ENVIRONMENTAL ASSESSMENT REPORT APPROVAL MODIFICATION NO.3

Barangaroo Headland Park and Northern Cove

Document Number: RPT-MOD3-001[4]

Barangaroo Headland Park and Northern Cove – Main Works
10_0048 Modification No.3

BARANGAROO HEADLAND PARK - UPDATED (S75W) SITE PLAN

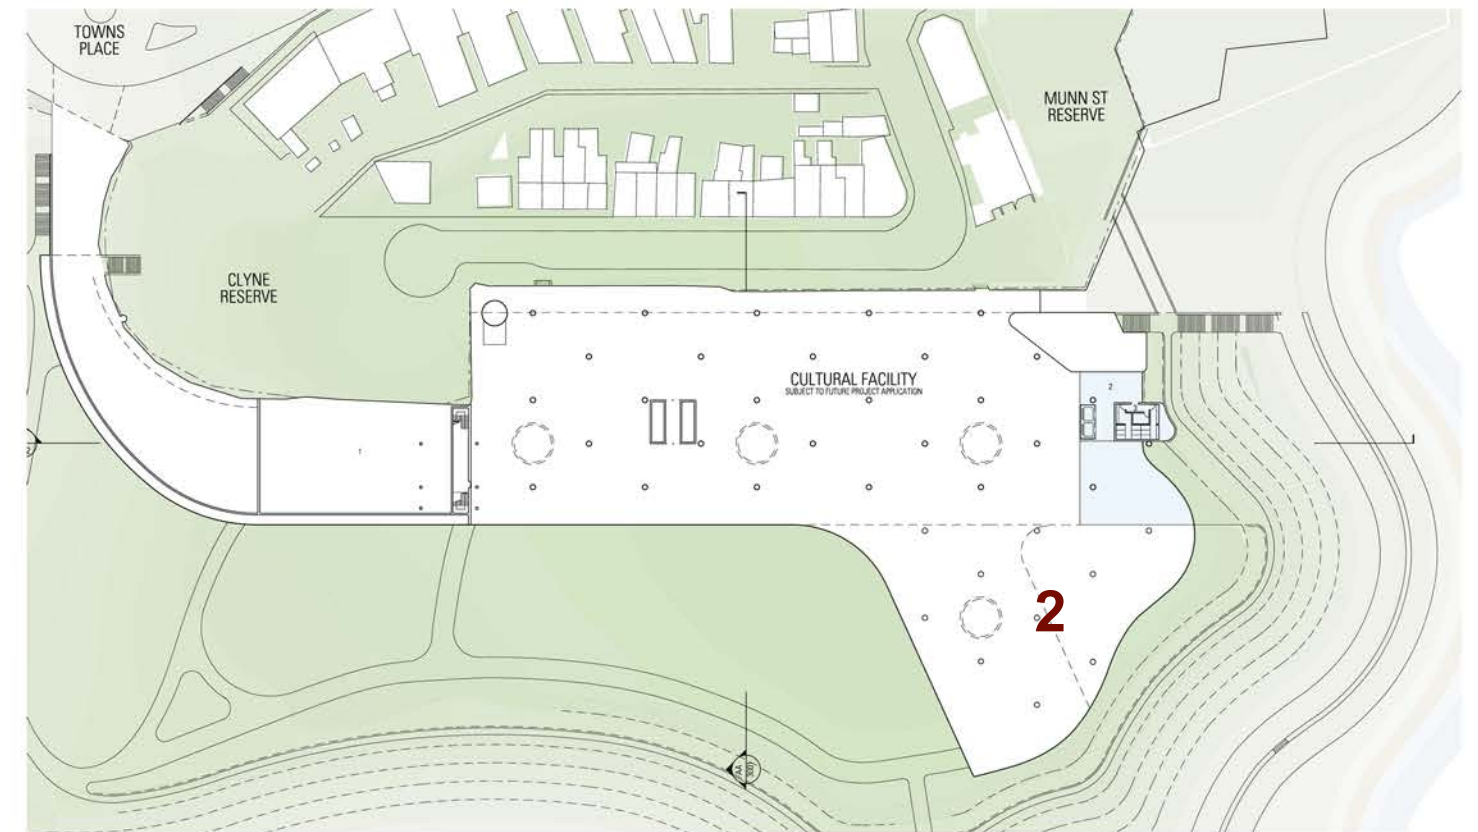
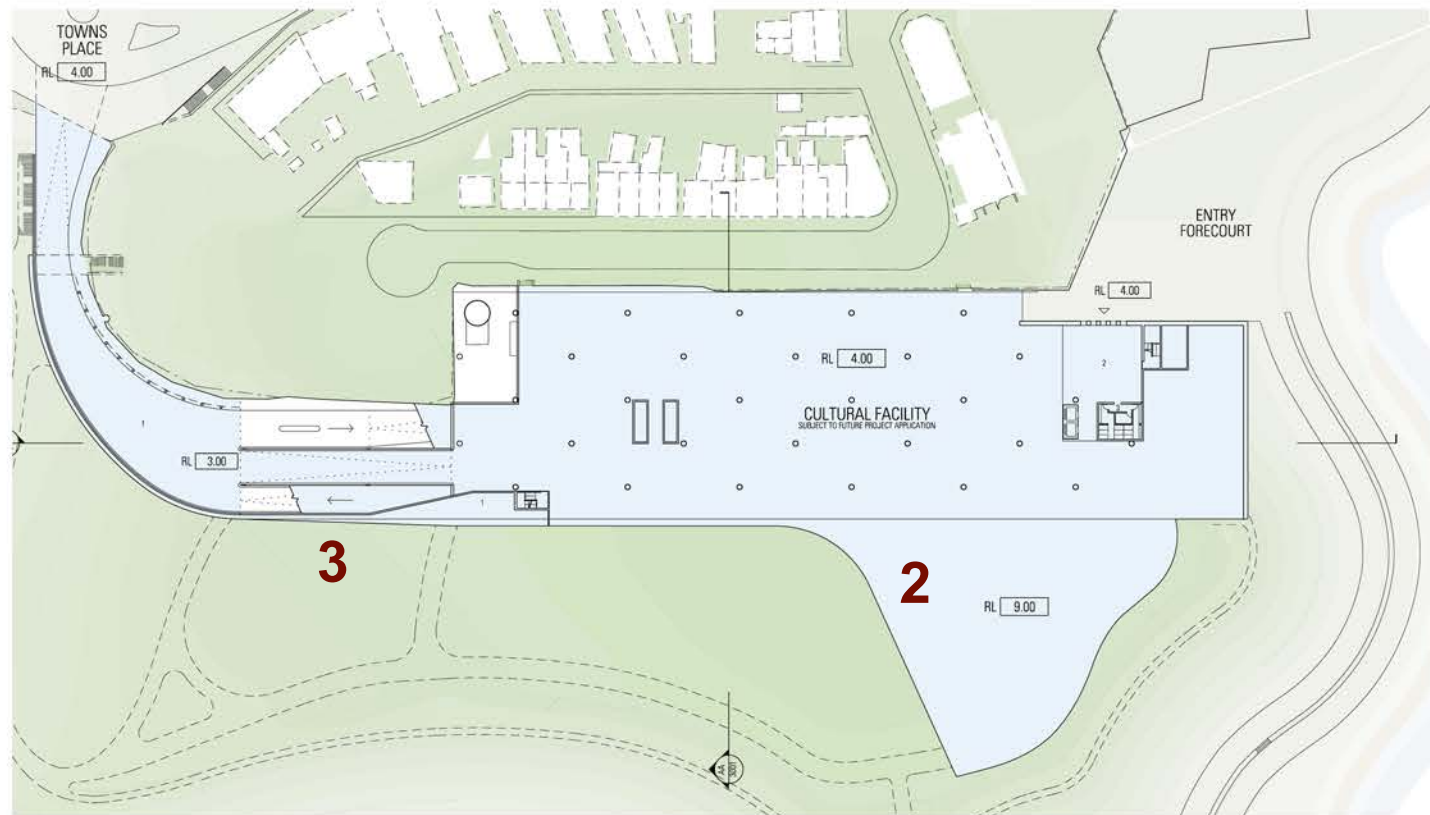
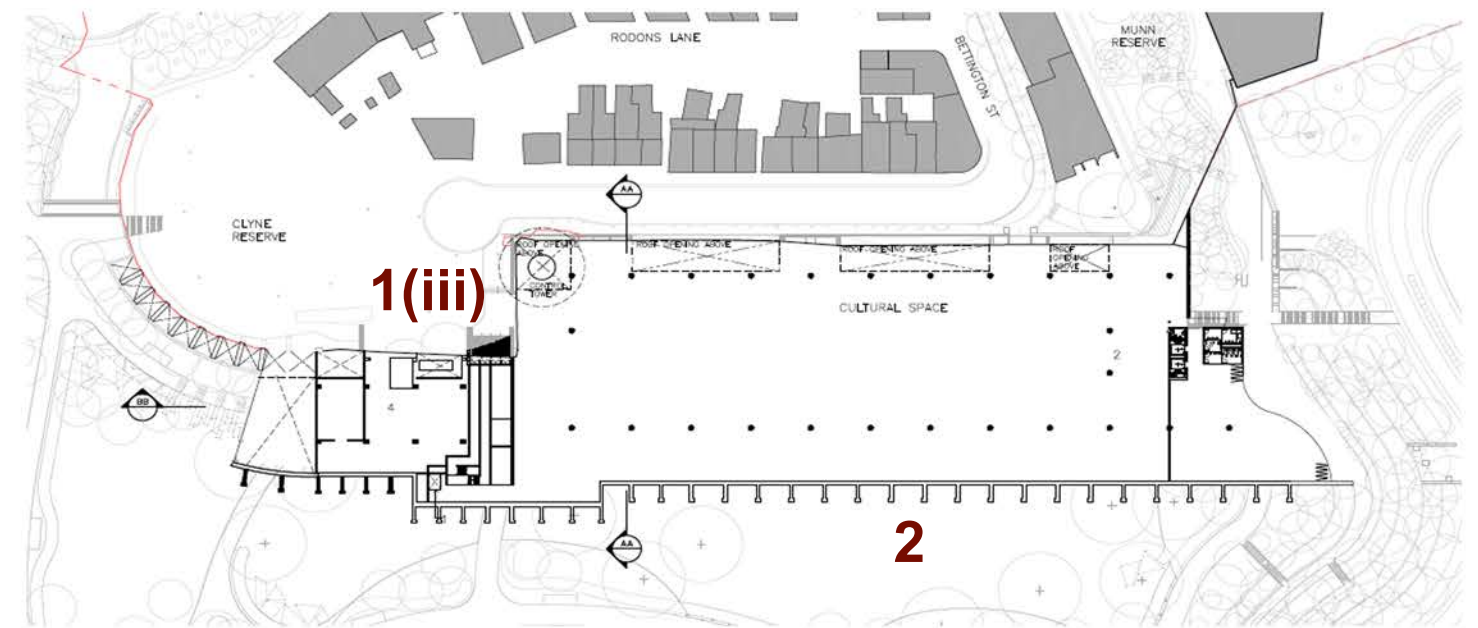
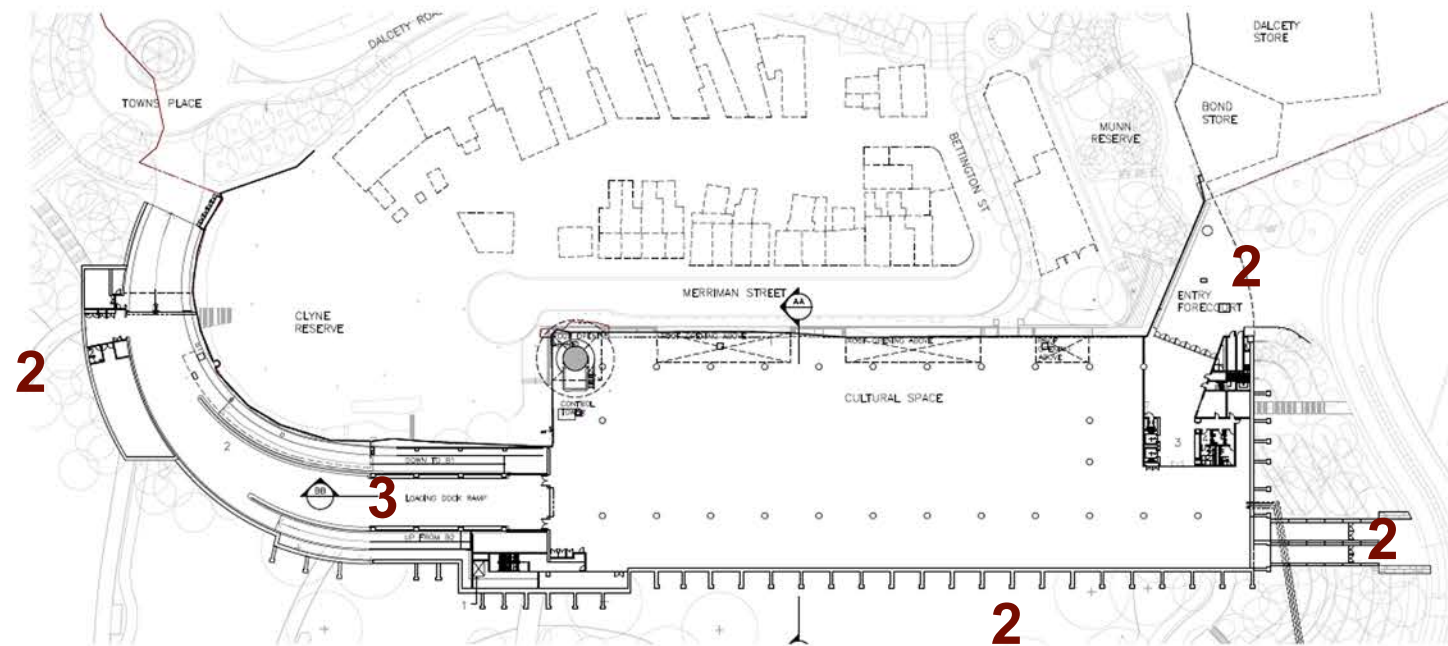
- Refer to Table 2-1
- 1(i) Various landscaping changes
- 1(ii) Moore's Wharf inlet changes
- 1(iii) Egress to Clyne Reserve
- 1(iv) Changes to Sewage Pumping Station 14
- 1(v) Third access bridge to Merriman Street
- 1(vi) Retention of historic sandsatone seawall
- 2 Cultural space entrance changes

BARANGAROO HEADLAND PARK - UPPER FLOORS

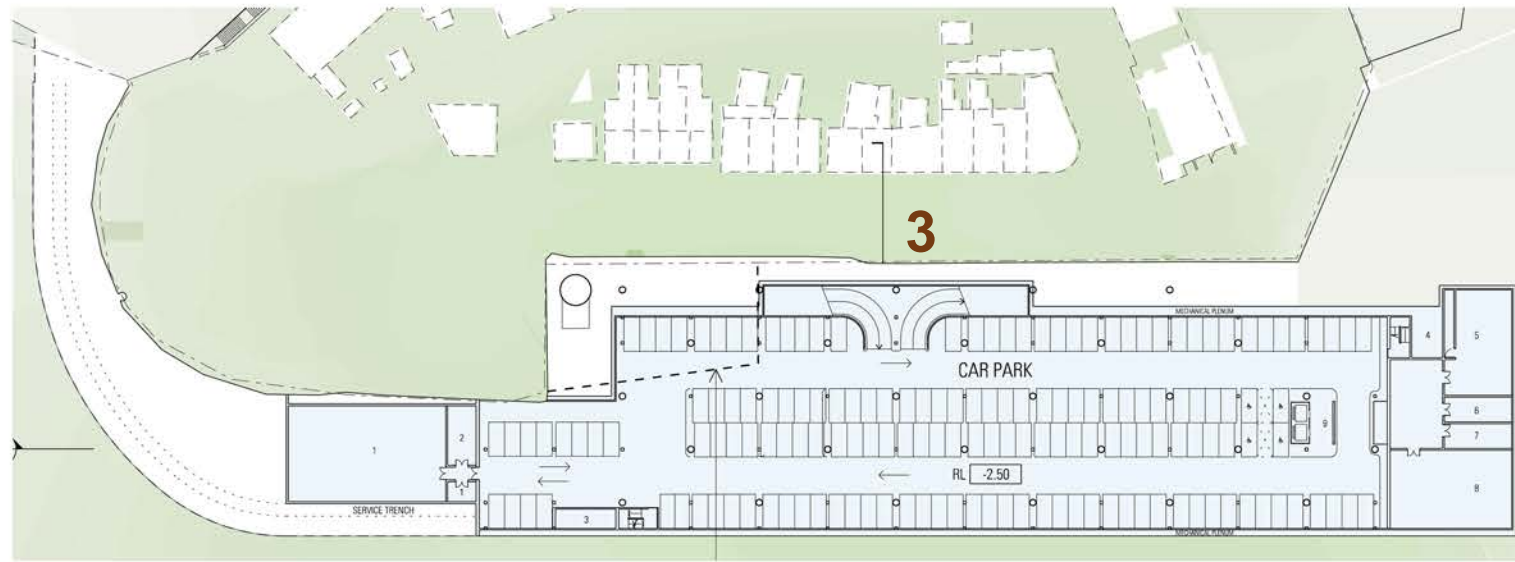
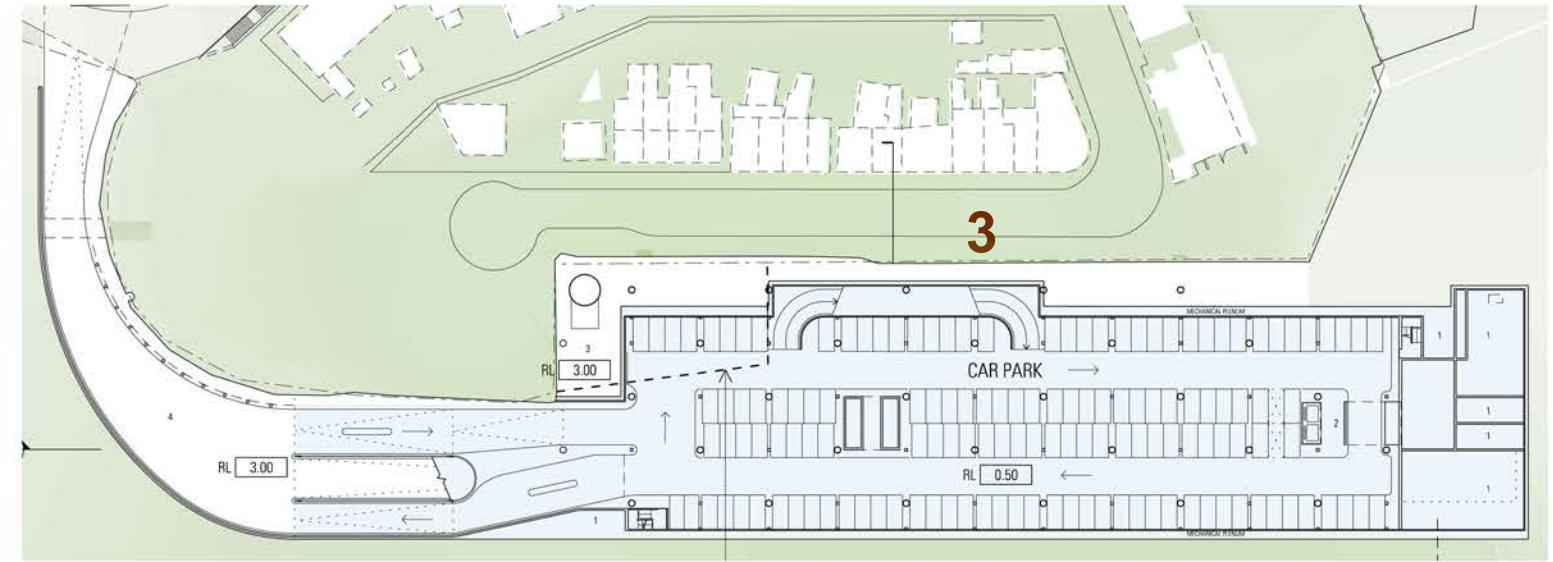
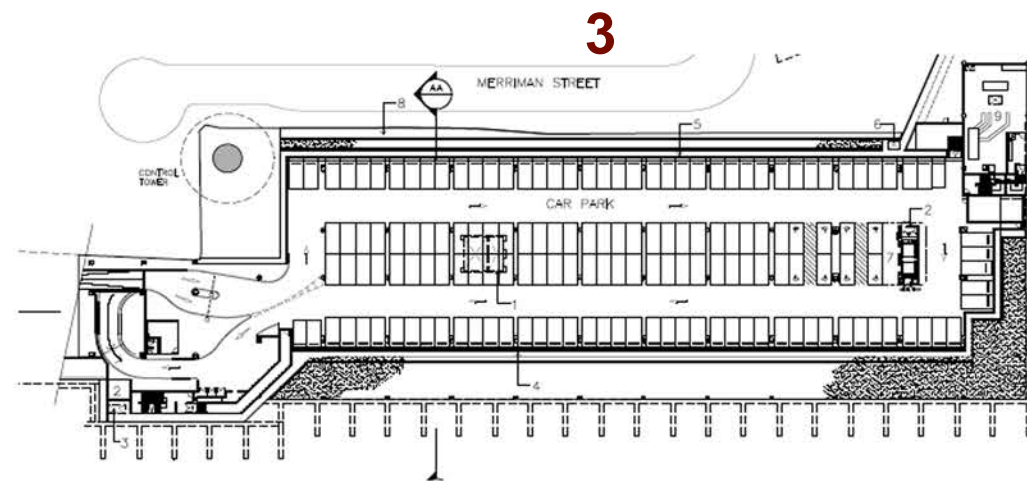
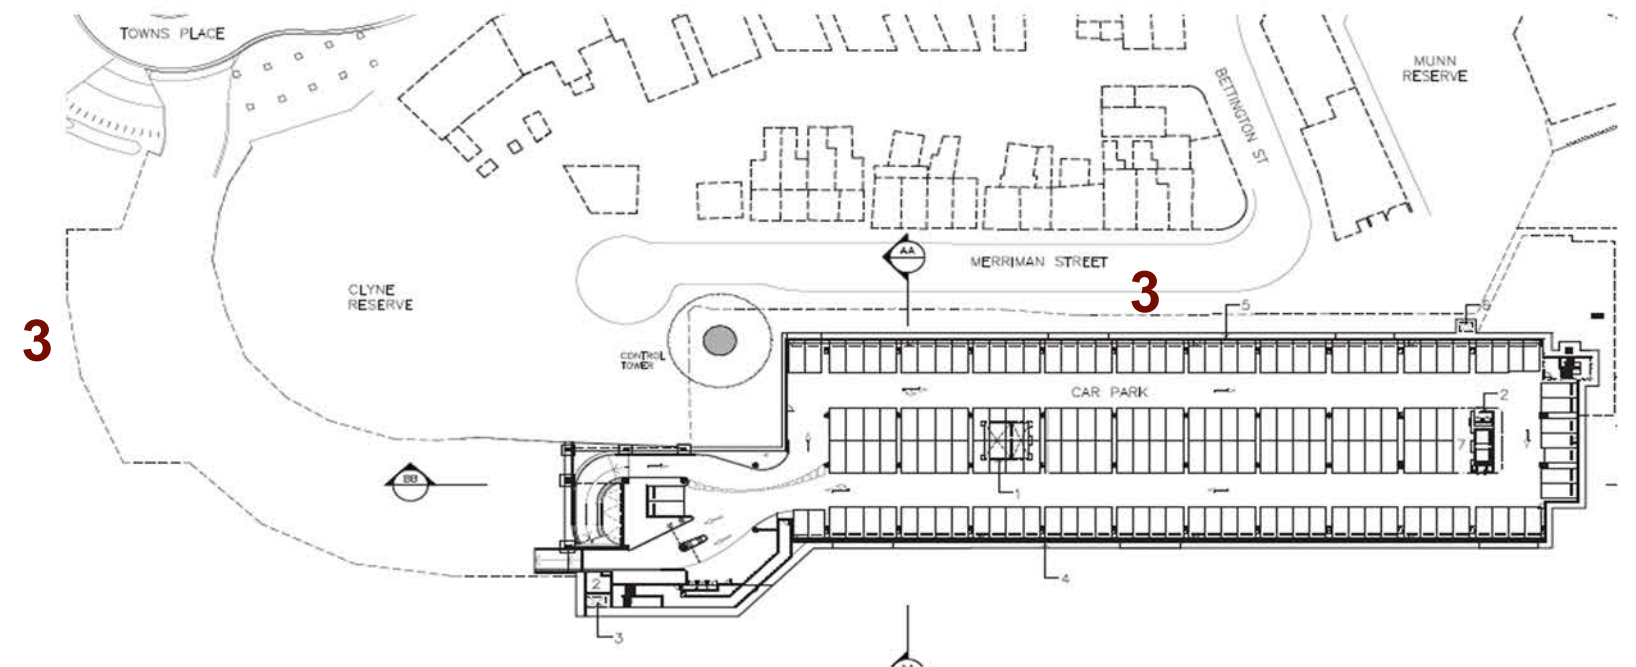
- 1(iii) Egress to Clyne Reserve
- 2 Cultural space entry and envelope changes
- 3 Changes to car park
